HISTORIC AND DESIGN REVIEW COMMISSION

HDRC CASE NO: 2020-060

ADDRESS: 124 ADAMS ST

TYPE OF WORK: Window Replacement
APPLICATION RECEIVED: January 30, 2020
60-DAY REVIEW: March 30, 2020
CASE MANAGER: Rachel Rettaliata

PROPOSED SOUTH ELEVATION

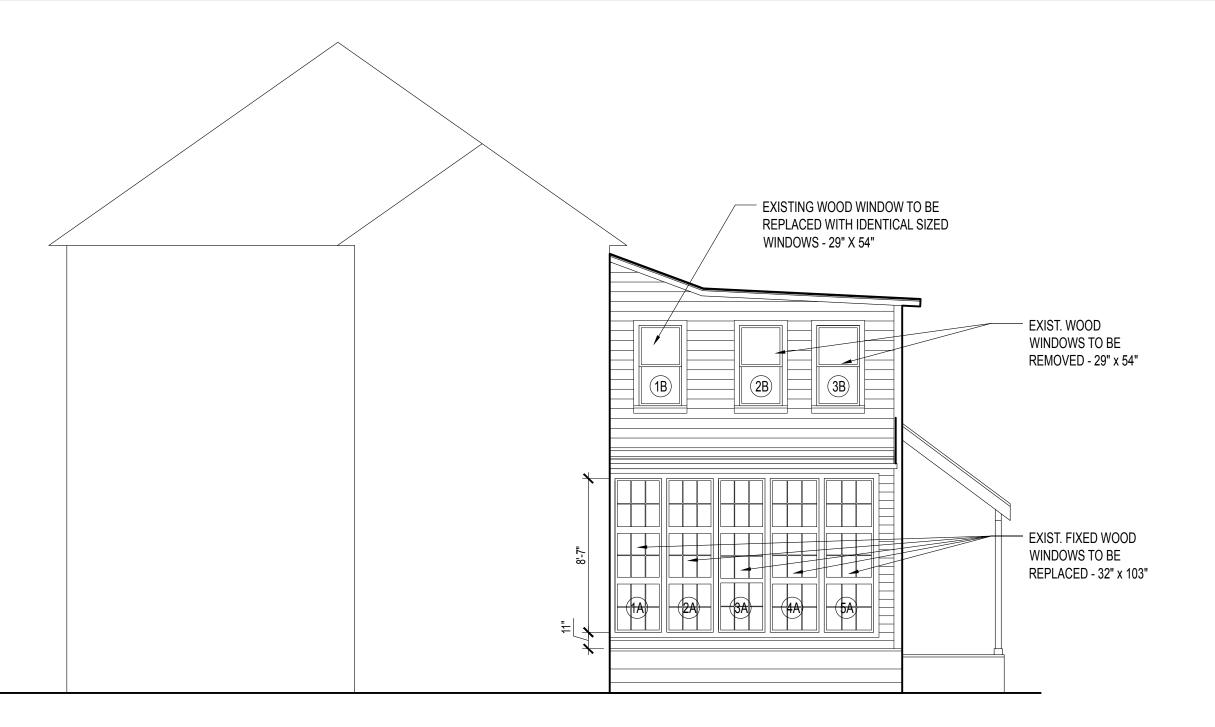
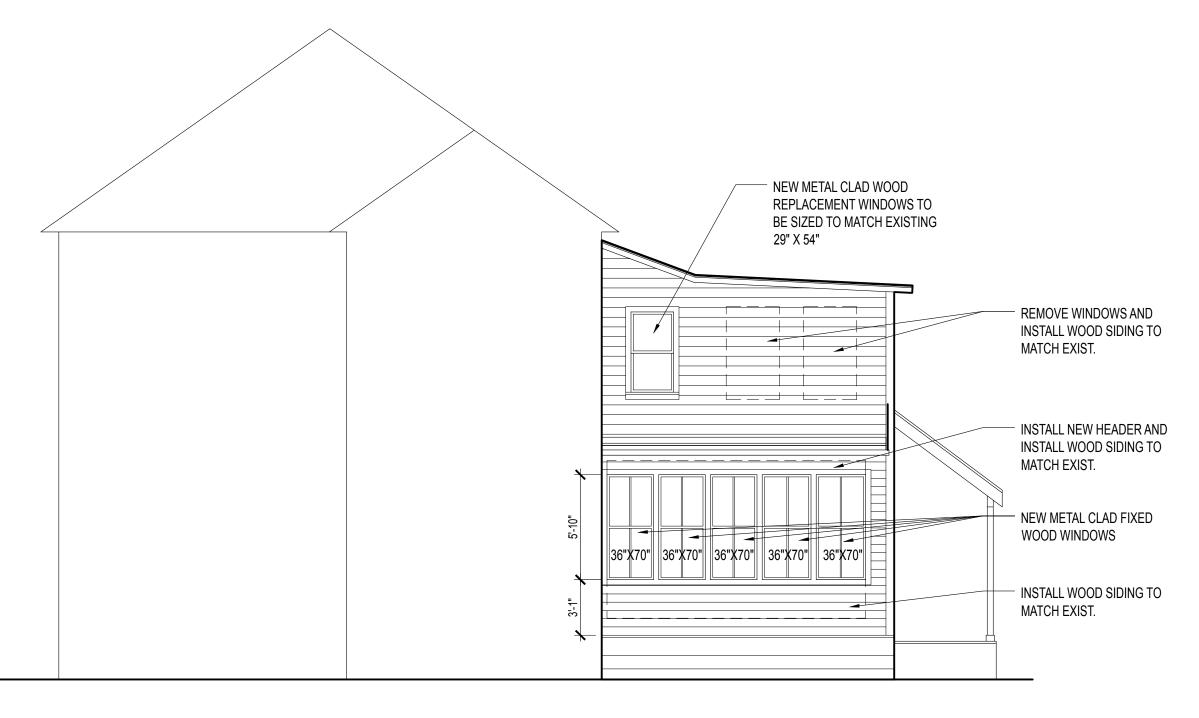
- d. WINDOW REPLACEMENT: SIZE The applicant has proposed to replace the existing bank of five windows on the south elevation with 5 fixed windows with a higher sill than the existing ganged windows. The sill height will allow the residents to maximize the interior space with furniture placement below the window sills. The applicant has proposed to also lower the header to match the adjacent proposed windows due to the requirements of a new structural header. The proposed windows on the south elevation will be 36"x70". The applicant has proposed to install wood siding to match the existing on the exterior. Due to the irregular size of the existing windows, staff finds the proposal appropriate. The applicant has proposed to replace the 3 ganged windows on the east elevation with 3 new double-hung windows. The lower third of the sash of the proposed windows will be operable. The sill height will match existing, but the header will be lowered due to the requirement of a new header to span the opening. The proposed new windows will be 36"x96". Staff finds the proposal appropriate.

- f. FENESTRATION MODIFICATIONS The applicant has proposed to remove 2 south-facing windows from the second-floor sunroom volume and install wood siding to match existing in order to create a more usable interior space. While the existing windows are likely not original to the structure, staff finds the proposal inconsistent with the Guidelines.

Item 2, Staff does not recommend the approval of window replacement on the second floor of the rear sunroom volume based on finding e.

Item 3, Staff does not recommend approval of fenestration modifications based on finding f.

6 PROPOSED EAST ELEVATION

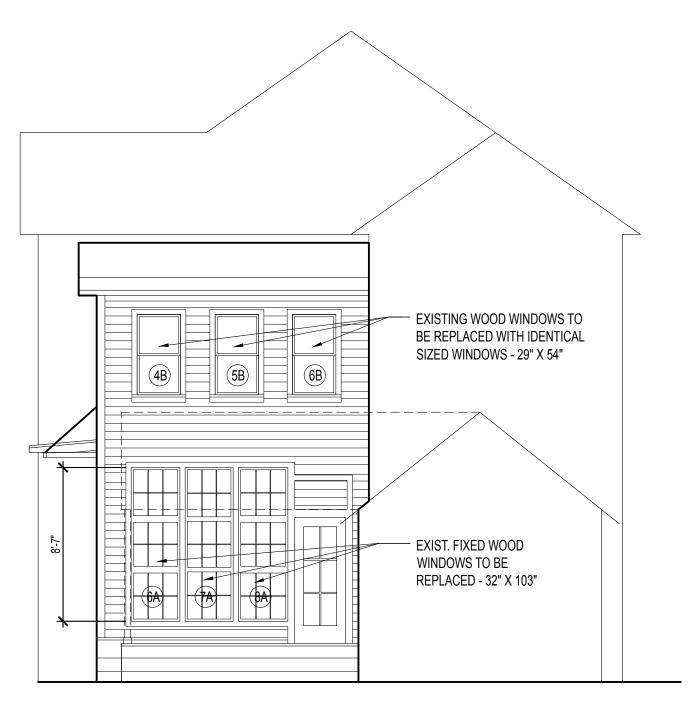
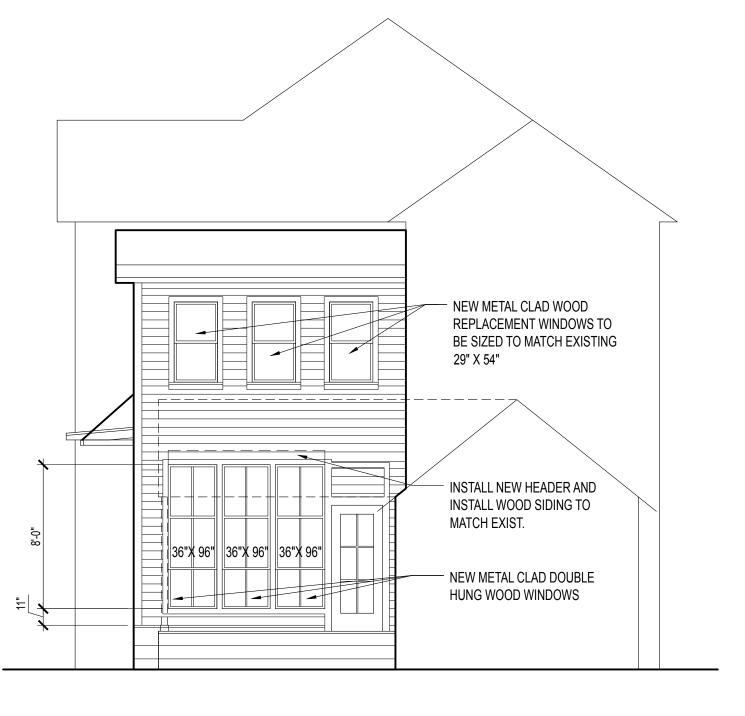
- b. WINDOW REPLACEMENT: FIRST-FLOOR SUNROOM The applicant has proposed to replace all existing windows on the first floor of the rear sunroom volume with aluminum-clad wood Pella Architect Series Reserve windows. The sunroom was enclosed circa 1975 to 1980 with a configuration of six-pane, historic-age sash windows stacked three sashes high and installed as fixed windows. There are 5 sets of these windows ganged on the south elevation and 3 sets of these windows ganged on the east elevation. Staff performed a site visit on February 7, 2020 and did not observe any significant damage to the fixed sunroom windows. However, according to Guidelines for Exterior Maintenance and Alterations 6.A.iii, and 6.B.iv, in kind replacement of windows is only appropriate when the original windows are beyond repair. Staff does not find that the existing windows on the first floor of the rear sunroom volume are original to the structure, although they are historicage. Staff finds replacement appropriate.

- c. WINDOW REPLACMENT: MATERIAL The Standard Specifications for Window Replacement stipulate that if replacement is approved, the new windows must feature primed and painted wood exterior finish. Cladded, composite, or non-wood materials options are not allowed unless explicitly approved by the commission. Staff does not find the proposed replacement material consistent with the Guidelines.

Item 1, Staff recommends approval of window replacement on the first floor of the rear sunroom volume based on findings a through d with the following stipulation:

i. That the applicant installs fully wood windows. The proposed aluminum clad replacement product is not appropriate. Meeting rails must be no taller than 1.25" and stiles no wider than 2.25". There should be a minimum of two inches in depth between the front face of the window trim and the front face of the top window sash. This must be accomplished by recessing the window sufficiently within the opening or with the installation of
